Southern California Edison Company

Subject: Docket Nos. 50-361 and 50-362
San Onofre Nuclear Generating Station, Units 2 and 3

ATTACHMENT I

EVALUATION
OF
POST-WELD HEAT TREATMENT PROCESSES

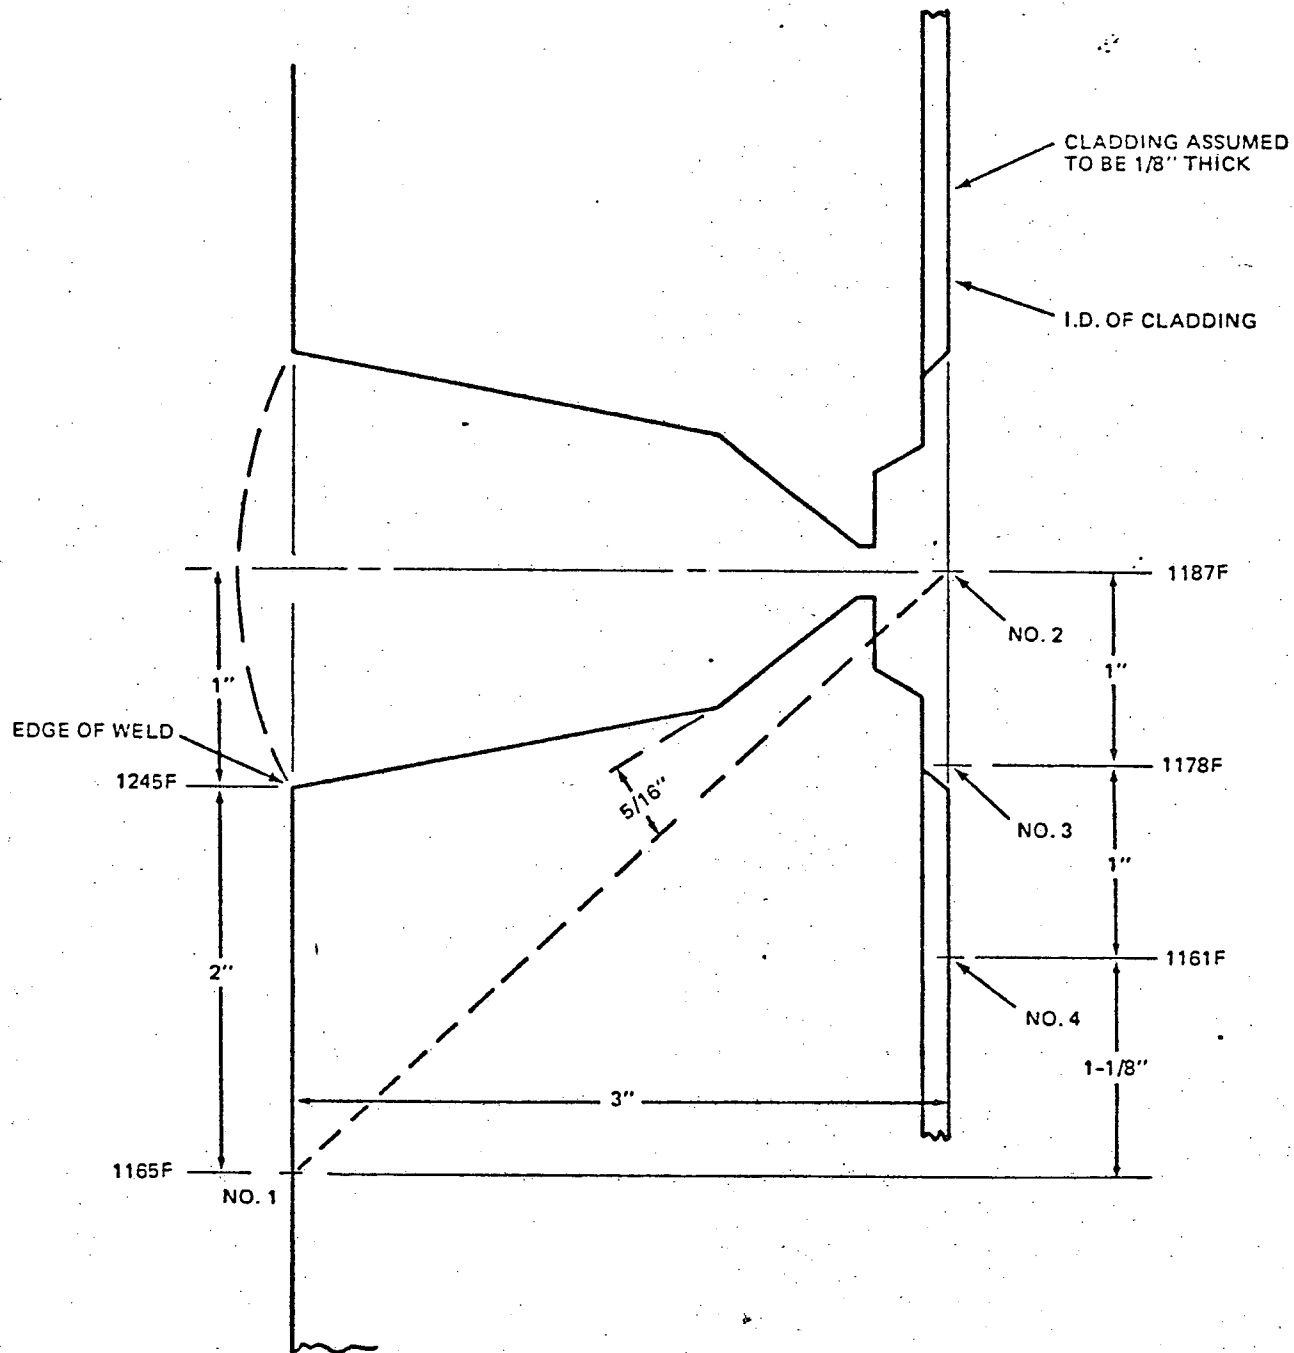
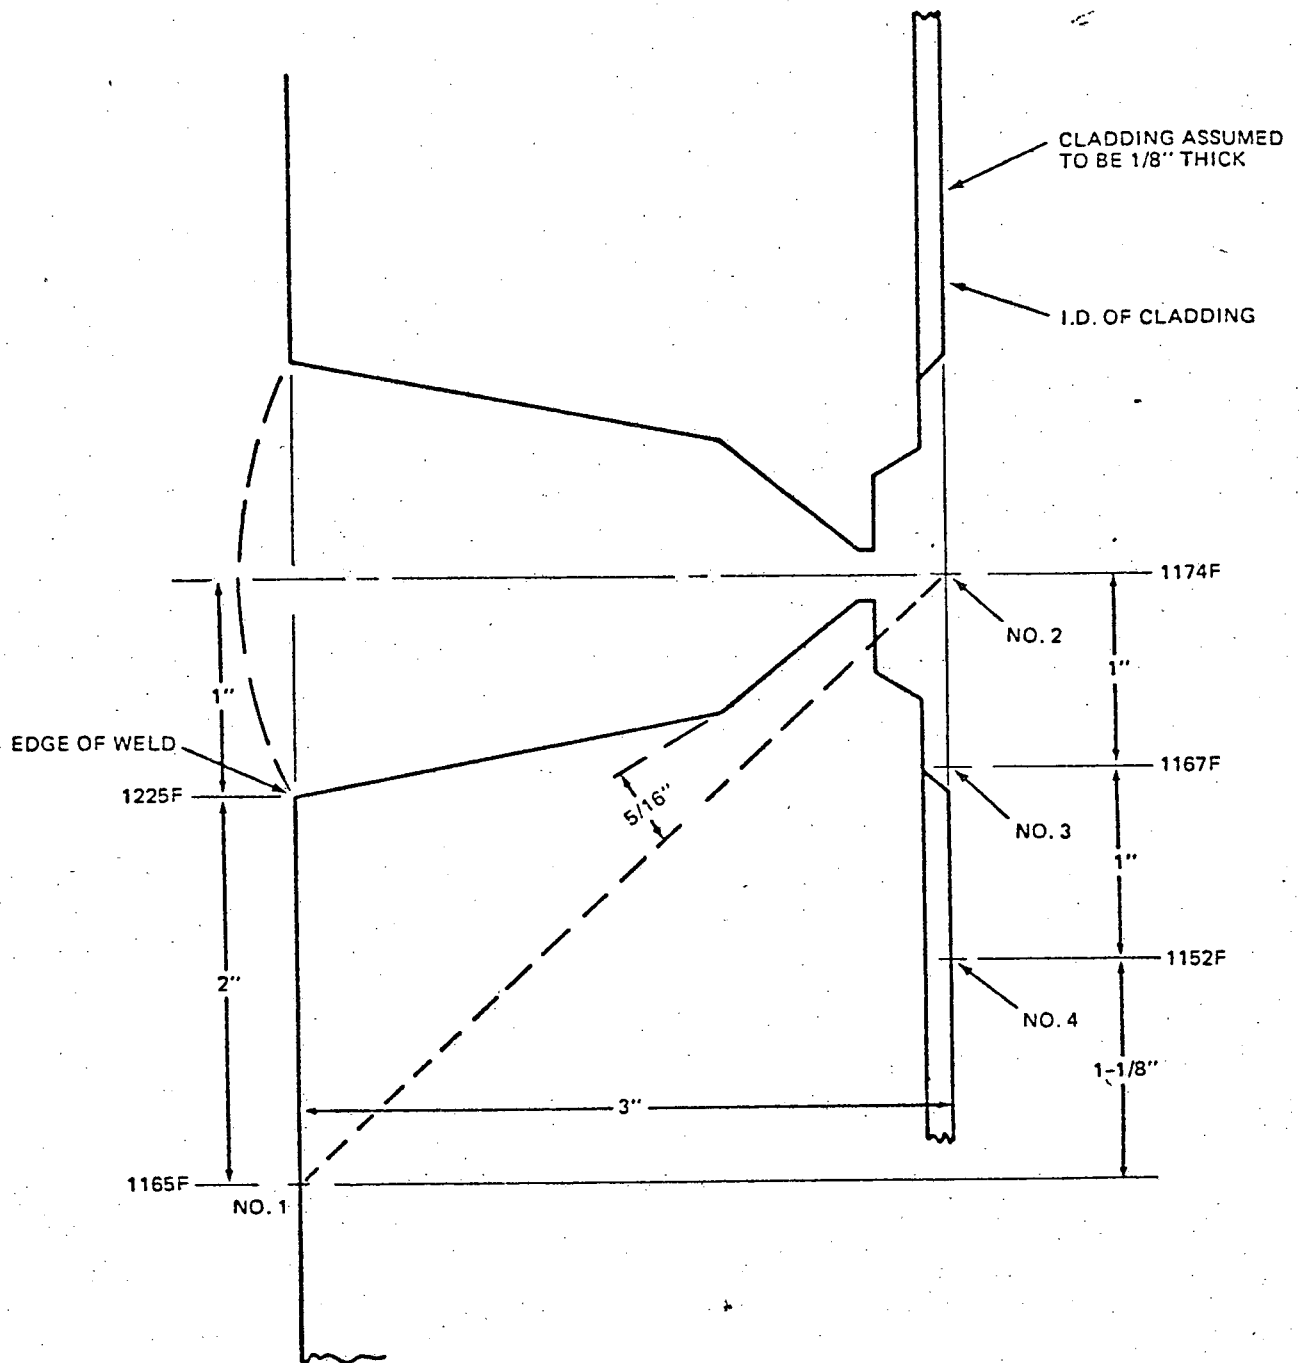
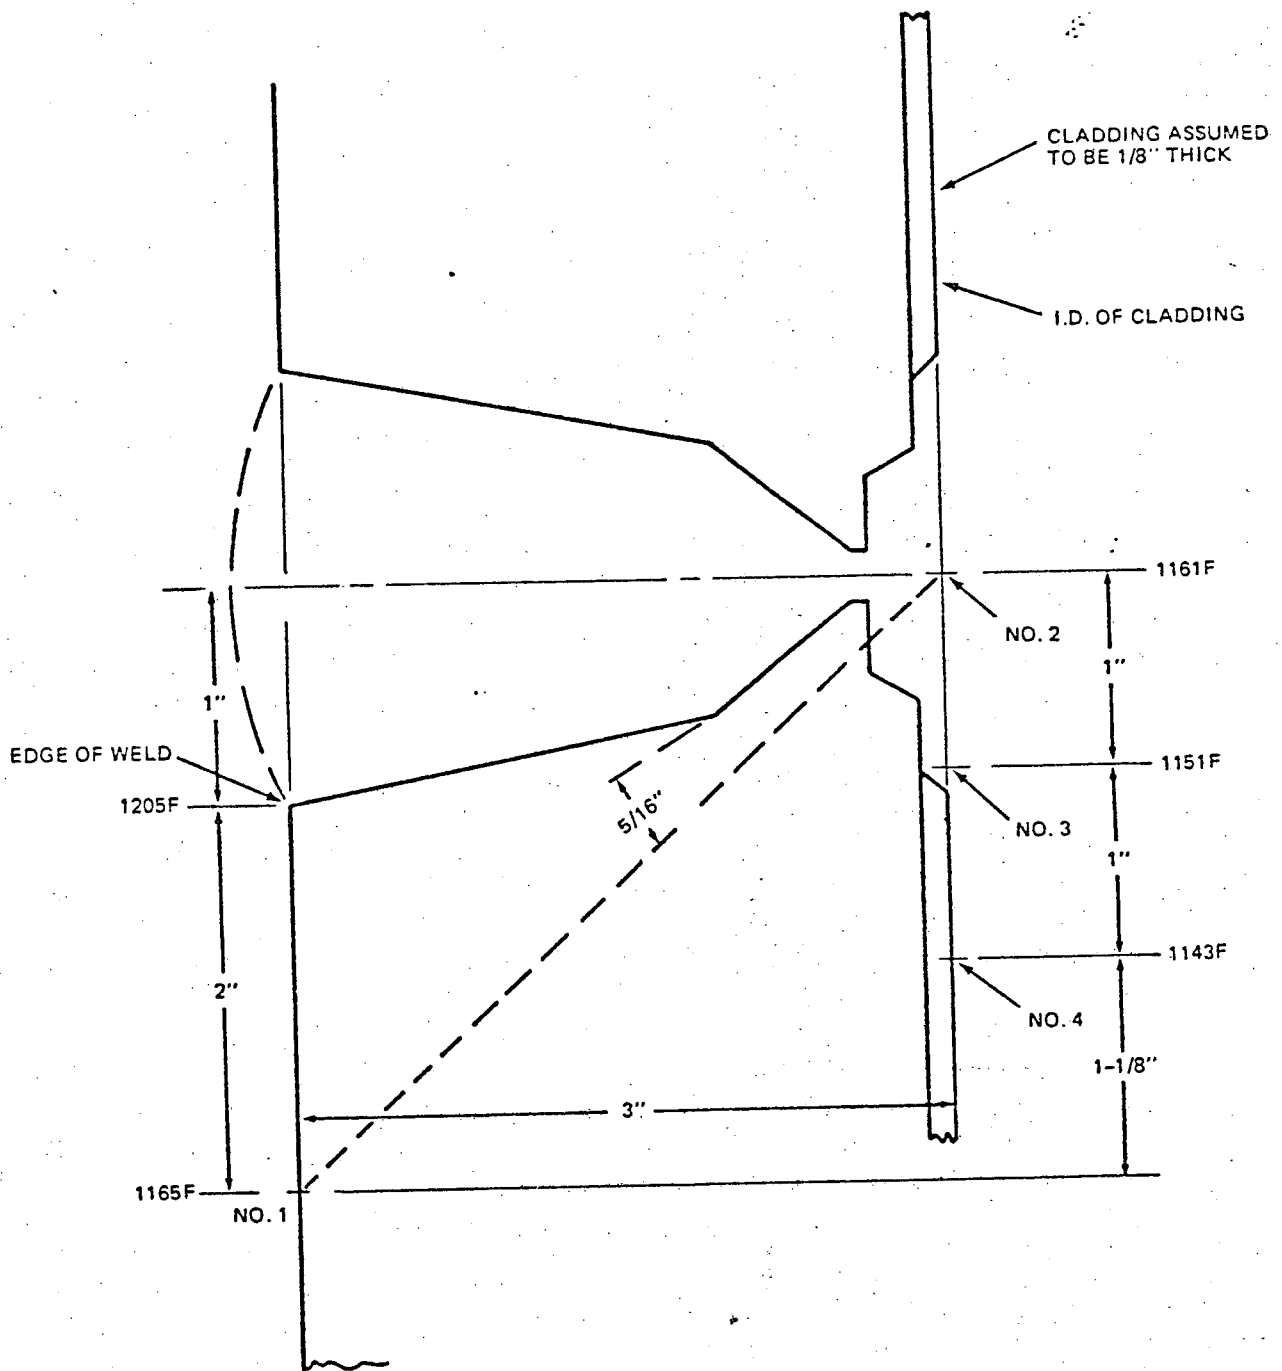
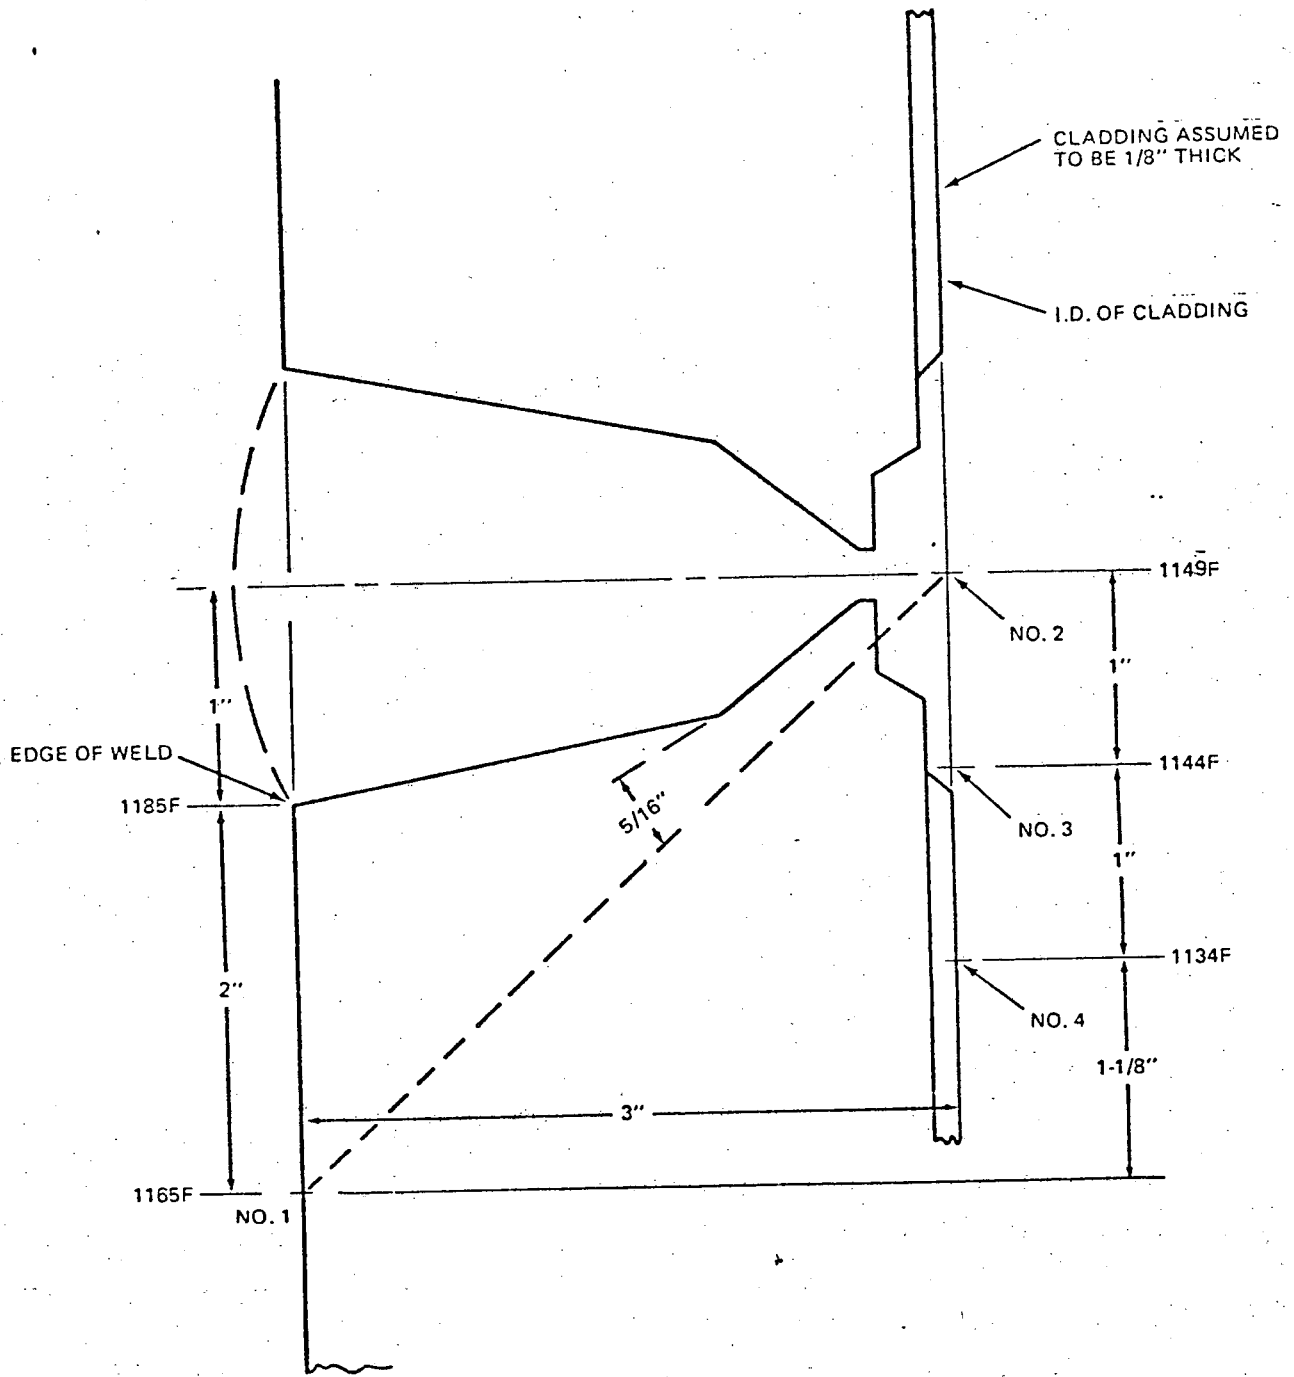
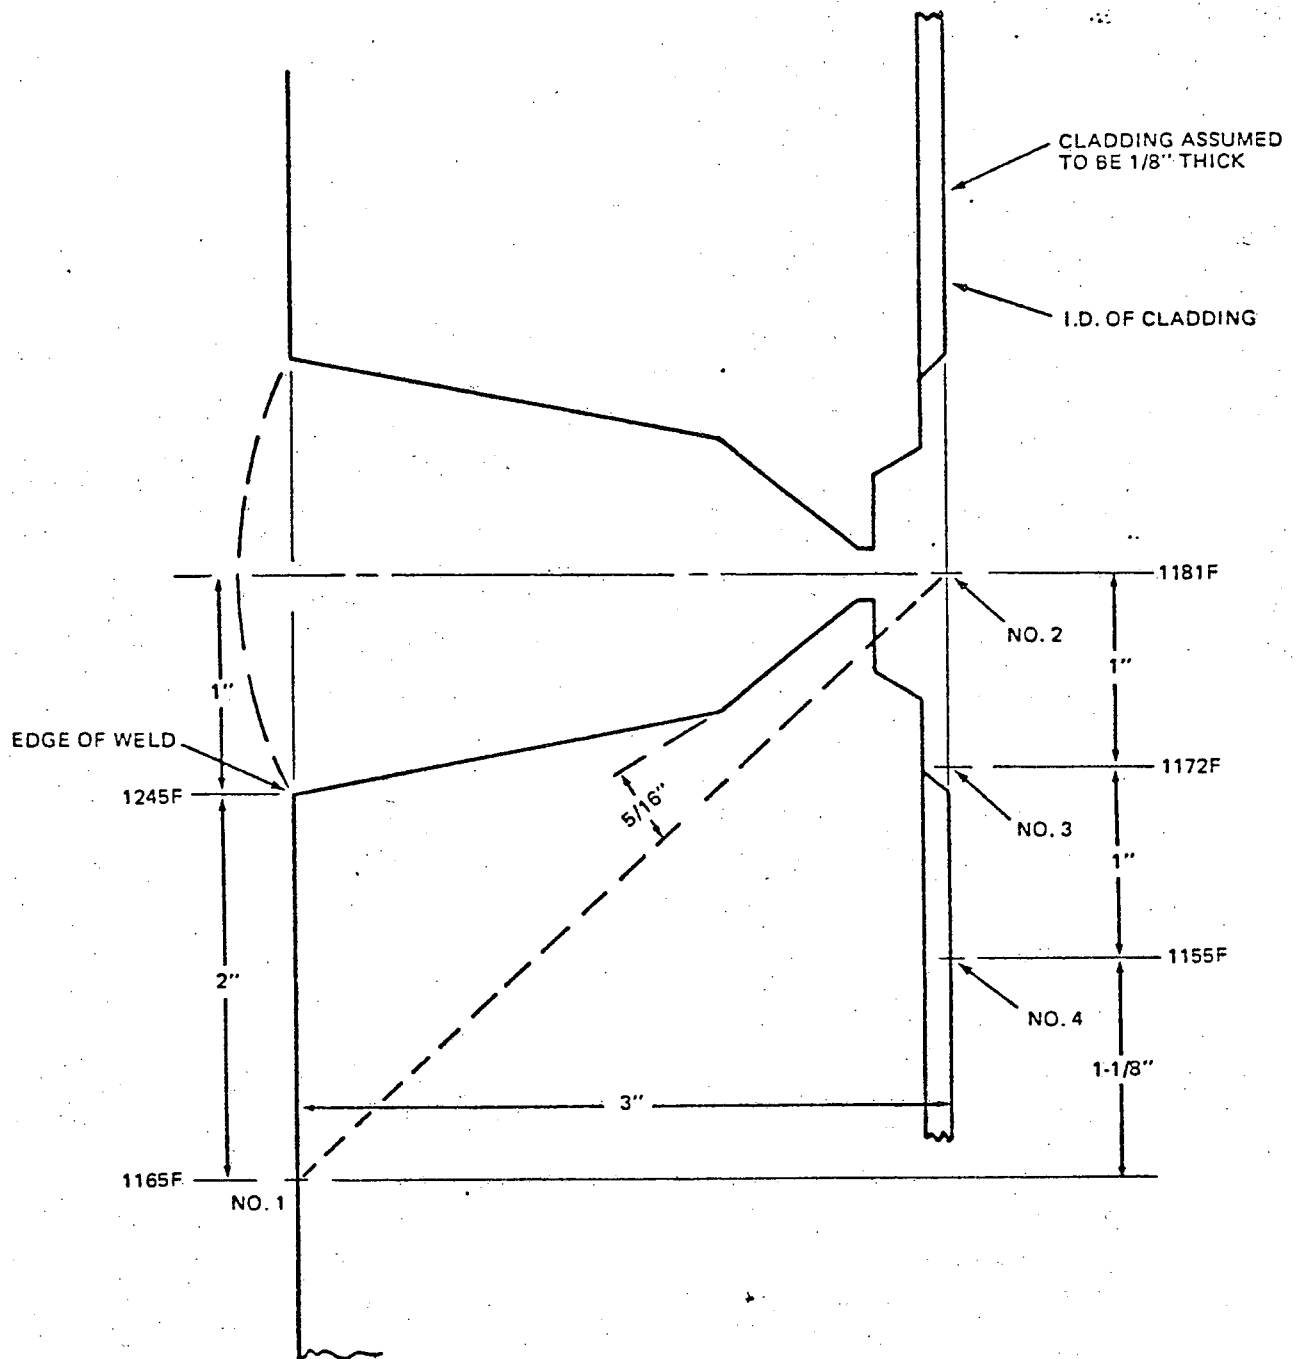
Contrary to the above, as of February 5, 1979, the post weld heat treating procedure using the quartz lamp technique had not been qualified before use to demonstrate that the minimum heat treating temperature of 1100°F, a design requirement, was met during the post weld heat treatment of main steam piping and reactor coolant piping welds. This procedure had been used since mid-1977 for heat treating the aforementioned welds at Units 2 and 3.

Figures D-1 through D-4 and D-5 through D-8 are in Appendix 4D and show the predicted inside pipe diameter temperatures for outside pipe diameter temperature gradients of 40, 30, 20 and 10F per inch. Outside pipe temperature gradients of 20 and 30F per inch are usually encountered in production welds. The 10 and 40F per inch gradients were modeled to bound the analysis. The pipe modeled had a 3-inch wall thickness, was in a vertical configuration, and had ends both blocked and unblocked. In all cases, a 10F/inch outside gradient yielded the lowest internal temperature. This configuration would yield the largest through-wall temperature gradients. With a reference temperature 2 inches from the weld edge of 1165F, the lowest internal temperature, 1 inch from the weld centerline (outside heat affected zone), calculated was 1138F with pipe ends unblocked. This is a maximum through-wall temperature gradient of 37F and confirms that the 3-inch and smaller wall thickness pipes are acceptable since these pipes were all heat treated at reference temperatures at least 40F above the required temperature. The effect of not blocking the ends of the pipe is an increase in the through-wall temperature gradient of 6F for the 3-inch wall thickness vertical piping.

The computer model predicted a temperature difference of minus 27F between the control thermocouple on a 3-inch thick vertical axis pipe and the internal weld centerline. The installation test data from Appendix C showed this temperature difference on a 3-3/8 inch thick (compared to 3-inch thick) vertical axis pipe to be 35F. This shows good correlation considering the thicker wall pipe, the difference in thermocouple placement, and the accuracy of the recorders. The good correlation justifies use of the program to predict the internal temperatures on thicker pipe.
